**Certificate of Appropriateness Application**  
**BAR 07-11-07**  
**400 East Jefferson**  
**TM 53 P 46**  
**Candace DeLoach**  
**Renovation**

**CITY OF CHARLOTTESVILLE  
BOARD OF ARCHITECTURAL REVIEW  
STAFF REPORT  
November 20, 2007**

**Certificate of Appropriateness Application  
BAR 07-11-07  
400 East Jefferson  
TM 53 P 46  
Candace DeLoach  
Renovation**

NEW FASCIA DETAIL - 400 BLDG.

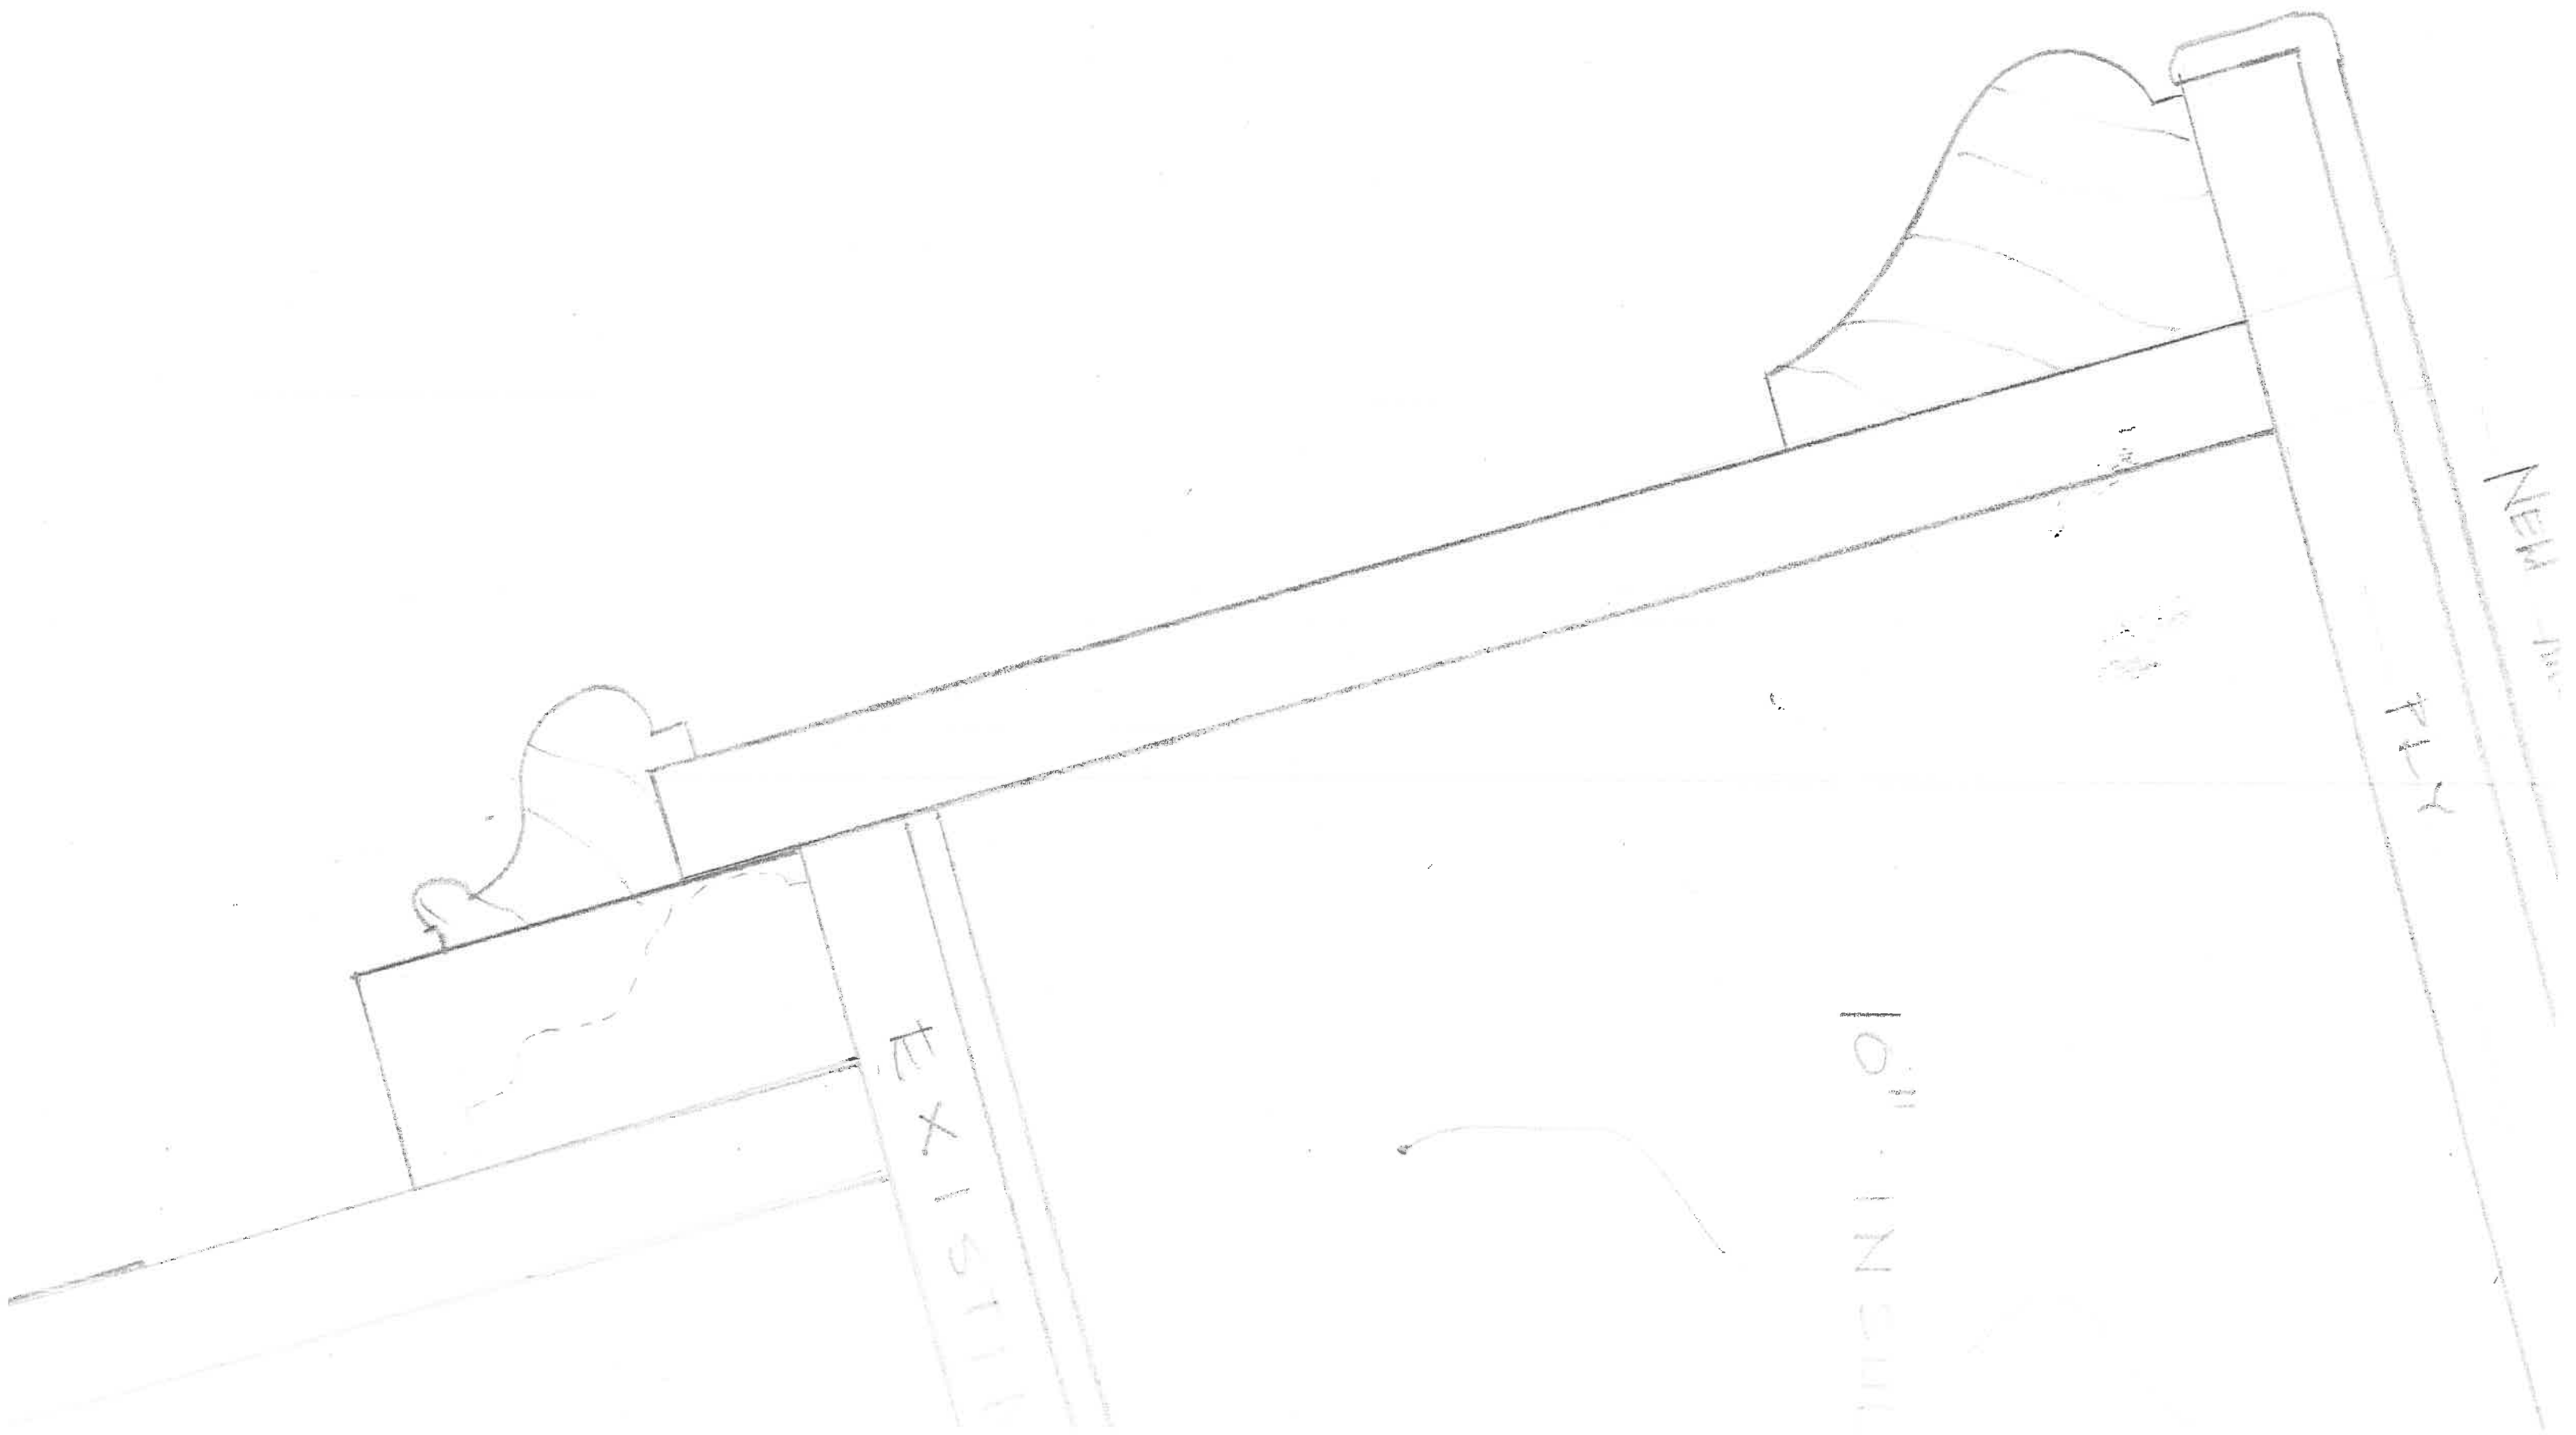
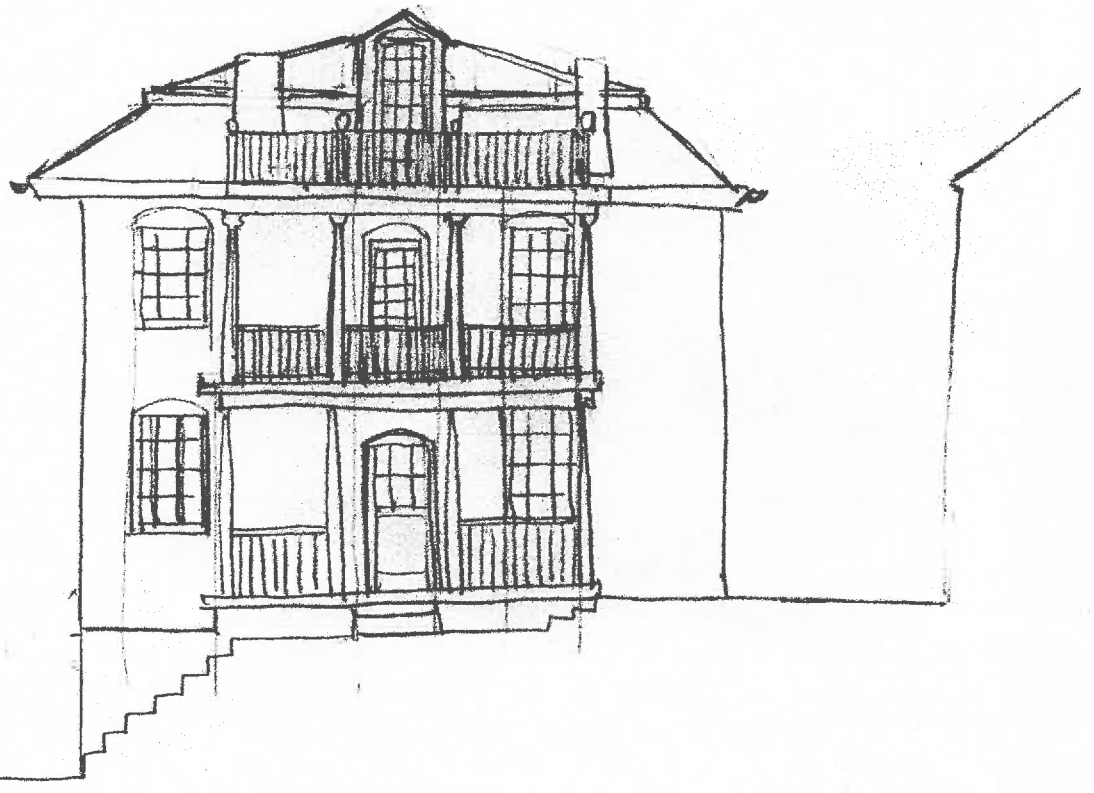
1. Add new (hand crimped) metal roof raised over existing metal roof to create 10" for R-38 insulation value for 3<sup>rd</sup> floor living space. Fascia plate between existing slate and metal will match existing fascia with decorative molding. The proposed metal roof will match the color of the slate mansard roof.

This is a new request. The guidelines recommend against changing the original roof pitch and configuration; and recommend against adding an additional story that would be visible on the primary elevation. The metal hip roof is not currently visible from the street. With the proposed raising of the roof, it could significantly change the appearance of the house.

Approved (6-0) item #1 to add a new hand crimped metal roof with insulated roof panels raised above the existing roof not to exceed 2 x 6 + sheathing (6-1/4 - 6-1/2" total) with fascia and trim details as submitted to match the color of the slate roof.

PROPOSED FRONT ELEVATION  
TO MATCH EXISTING REAR ELEVATION

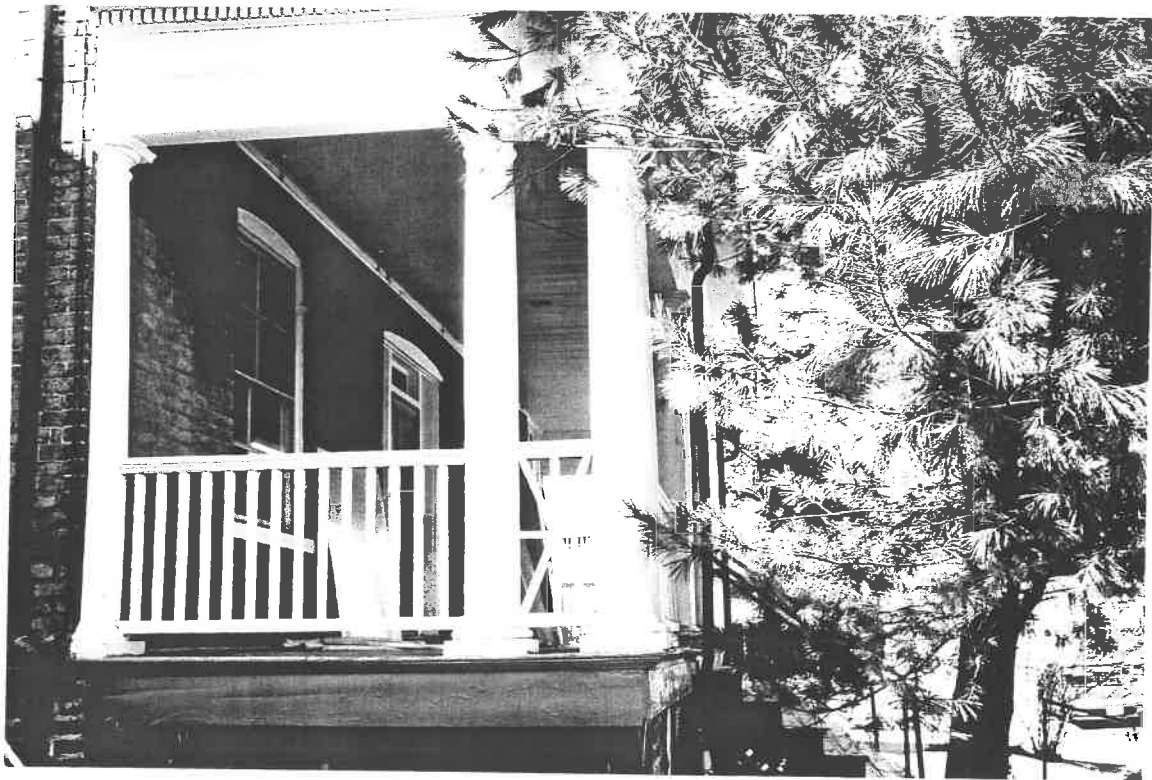
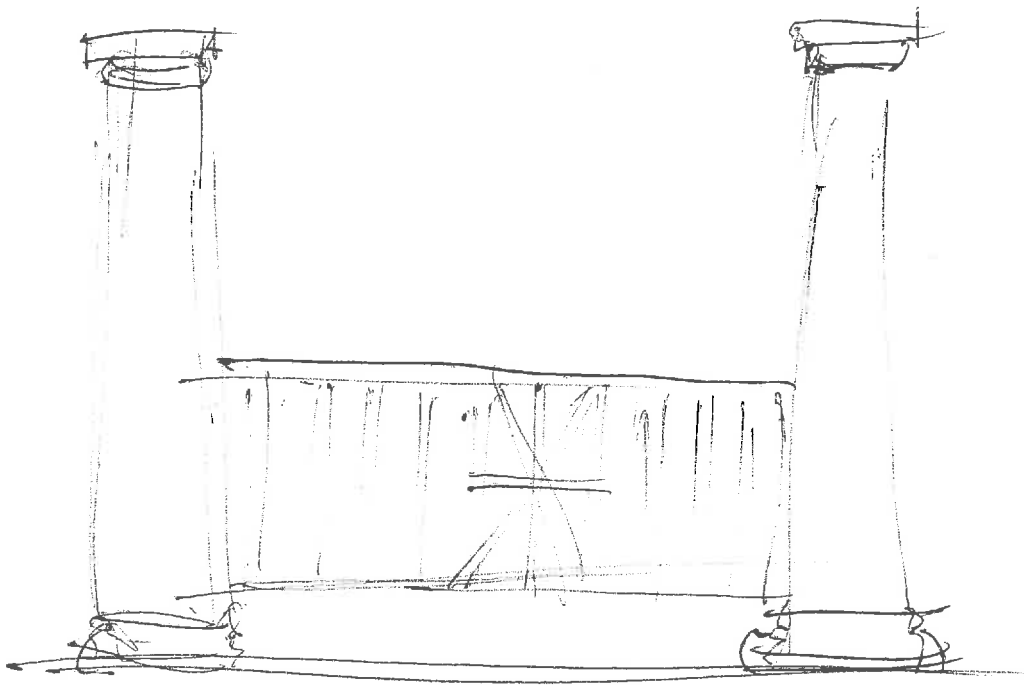
5. Replace front porch brick columns with 12" round wood Doric columns with wood bases to match original back porch;

The guidelines recommend that the original porch with square brick supports should be retained if it is important in defining the building's overall historic character. The proposed change was previously approved by the BAR on 4-15-2003.

- #5 Replace the front porch brick columns with 12" round wood Doric columns with wood bases to match original back porch;
- #6 Replace brick front porch brick railing with wood railing (spindle design with centered "x");
- #7 Replace missing original railings on upper 2<sup>nd</sup> floor porches, front and back, with wood railings to match 1<sup>st</sup> floor designs;
- #9 Keep existing metal railing and add new decorative wood detail to brick at front steps (or) keep metal railing but remove bricks. This was previously allowed with staff approval but not the ornate fan. Staff will bring it back to the BAR if an issue.
- #10 Add two dormers on driveway side to match street side dormers.

EXISTING BRICK RAILING

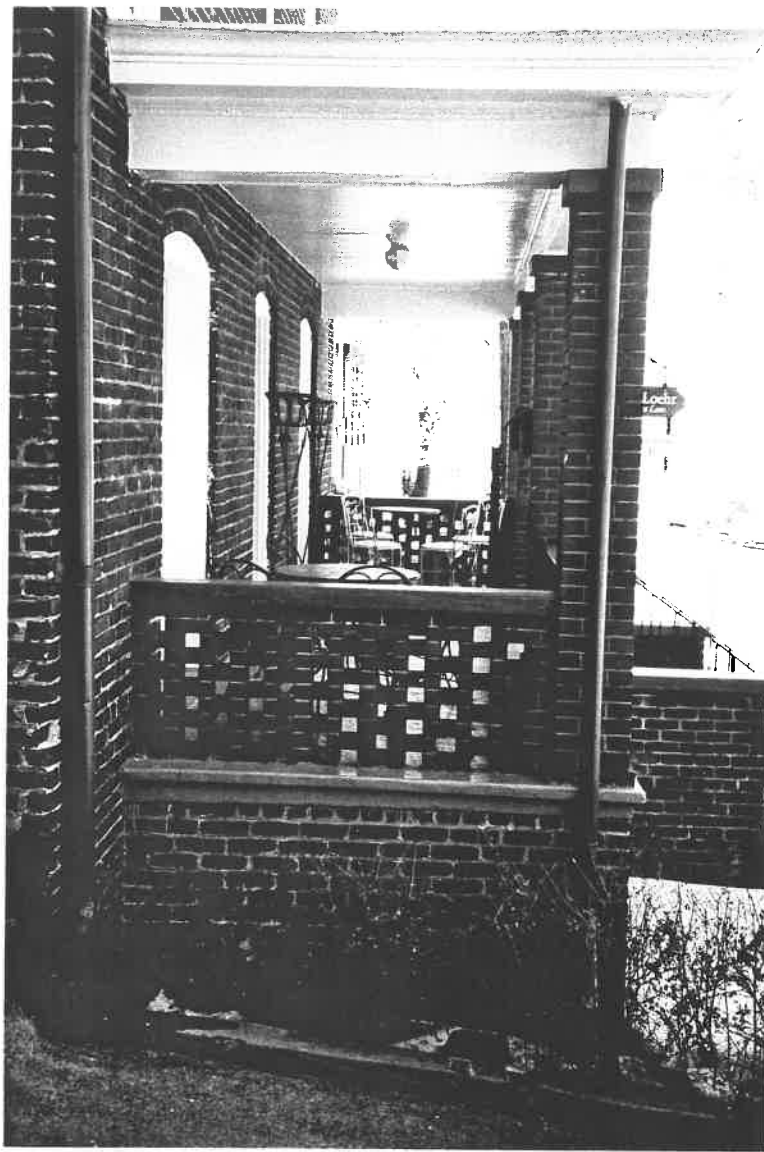
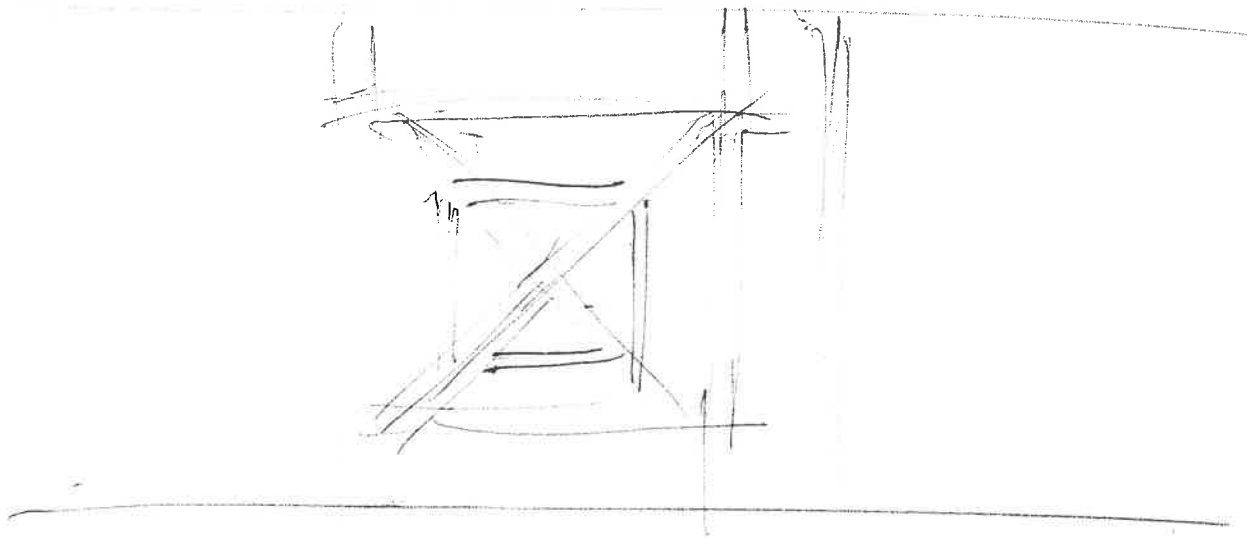
6. Replace brick front porch brick railing with wood railing (spindle design with centered "x");

It is unknown if the perforated brick railing is original. The rear spindle porch railing seems like a good model to repeat, however, the guidelines do allow giving more importance to a front porch than back. The proposed change (with centered "x" design) was previously approved by the BAR on 4-15-2003.

Proposed Decorative Stair Element

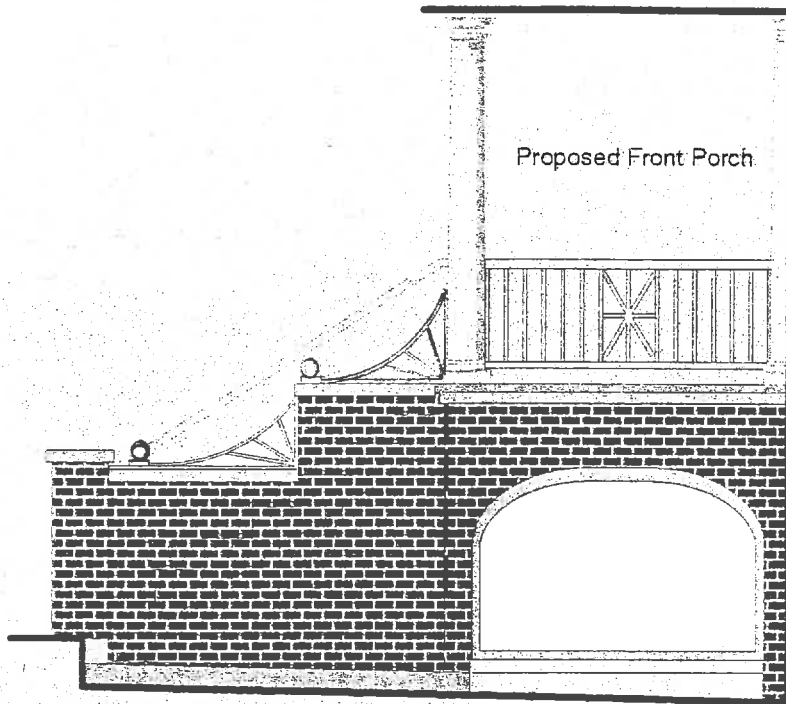
9. Keep existing metal railing, and add new decorative wood detail to brick at front steps (or) keep metal railing but remove bricks.

The BAR rejected the decorative stair element on 4-15-2003 because the fan design was too ornate. This request needs to be clarified – a drawing is needed.

Please submit additional information for staff approval of: decorative front stair detail; awnings; and skylights.

PROPOSED WINDOWS IN DORMERS  
COURT SQUARE BUILDING

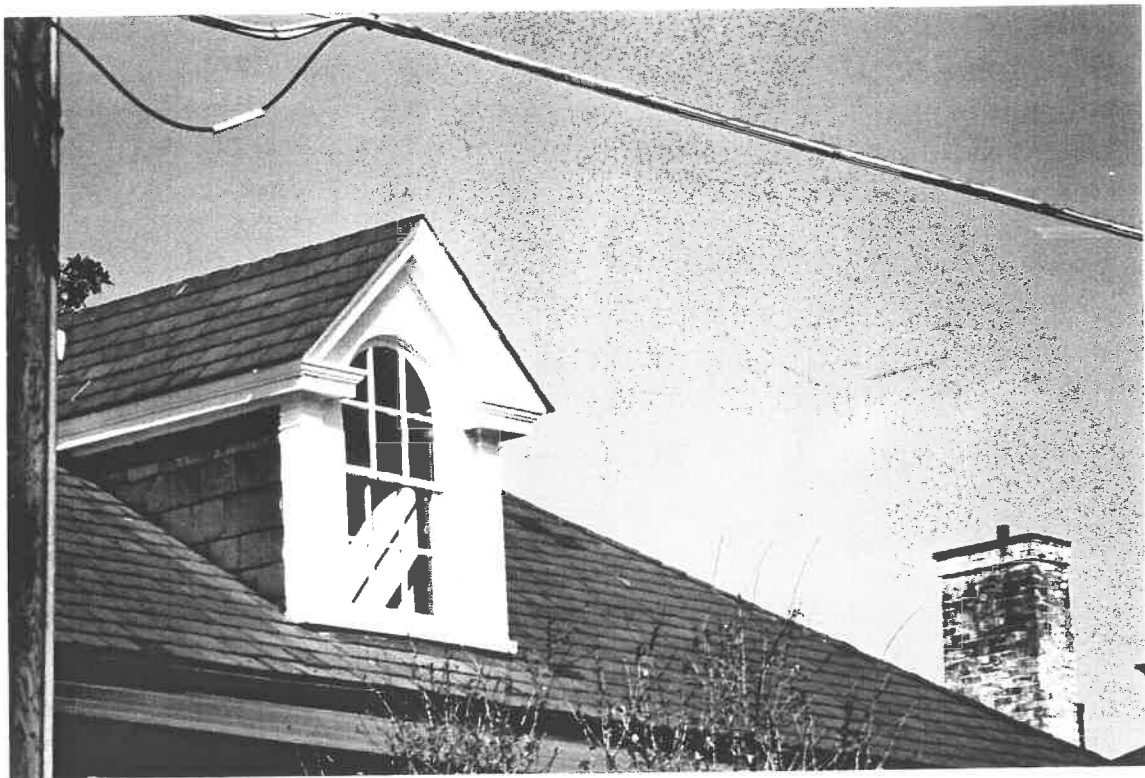
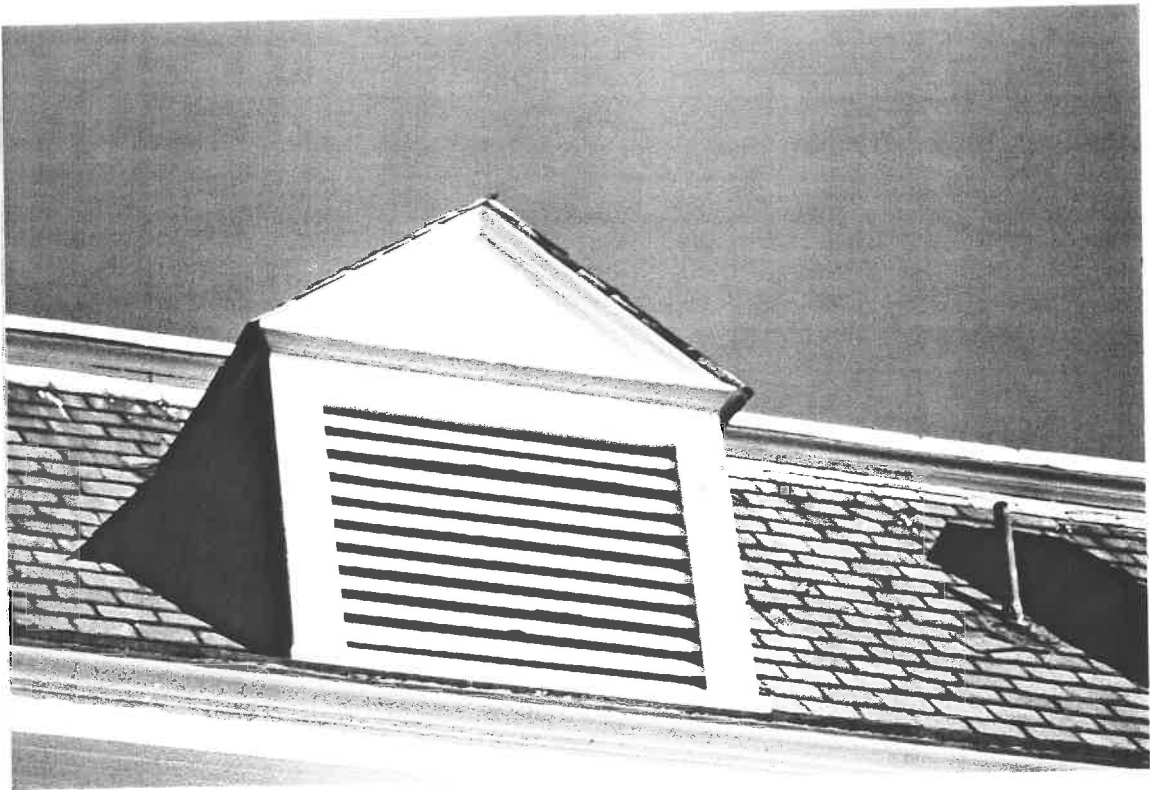
11. Replace all dormer vents with wood casement windows with a slightly arched frame.

It is not known if the vents are original, or if the dormers may have contained windows. The guidelines recommend against changing the original size and shape of the dormers. Windows could be added without changing the size or shape. The proposed window is a wood casement window, 6-light, flat on top but with an arched frame. This request was previously approved by the BAR on 4-15-2003.

- #11 Replace all dormer vents with wood casement windows with a slightly arched frame.
- #14 Replace upper (2<sup>nd</sup> floor) front and rear porch doors with 15-pane wood doors. (Door frames would not be altered.)
- #15 Add gas lantern on post in front of building next to driveway.
